Docket No. 030186U2

Serial No. 10/770,878

Amendments to the Drawings:

REMARKS/ARGUMENTS

## FIGURE 4

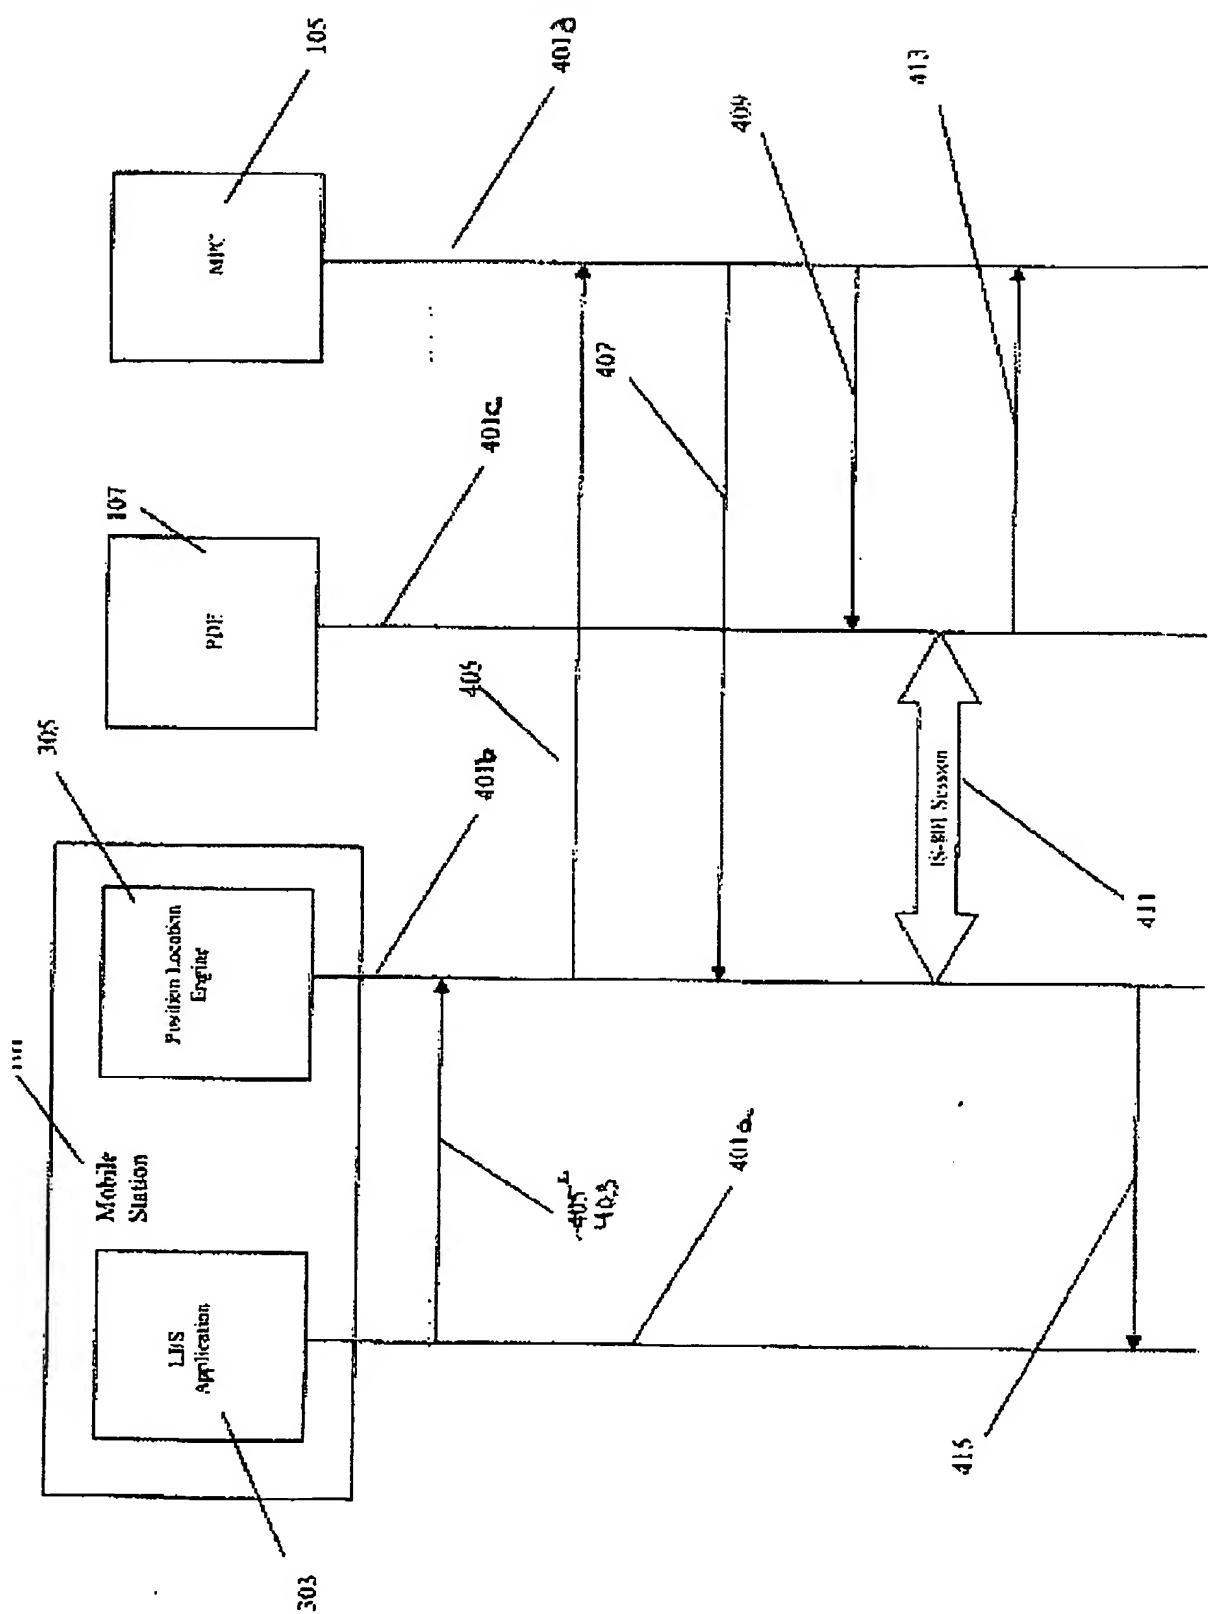
The drawings were objected to for failing to show elements 401a, 401b, 401c, 401d, and 403 in FIGURE 4, as described in the specification.

Applicant amends FIGURE 4 to correct the reference designators to correspond to the description at paragraphs [1027] and [1028]. In particular, the four instances of reference numeral "401" were revised to illustrate "401a", "401b", "401c", and "401d". Applicant believes that the specification is clear that reference identifiers 401a, 401b, 401c, and 401d refer to the vertical lines extending from blocks identified, respectively, with 303, 305, 107, and 105. Additionally, the typographic error to the arrow from the LBS application to the Position Location Engine has been changed from "405" to "403" to conform to the specification, at paragraph [1028].
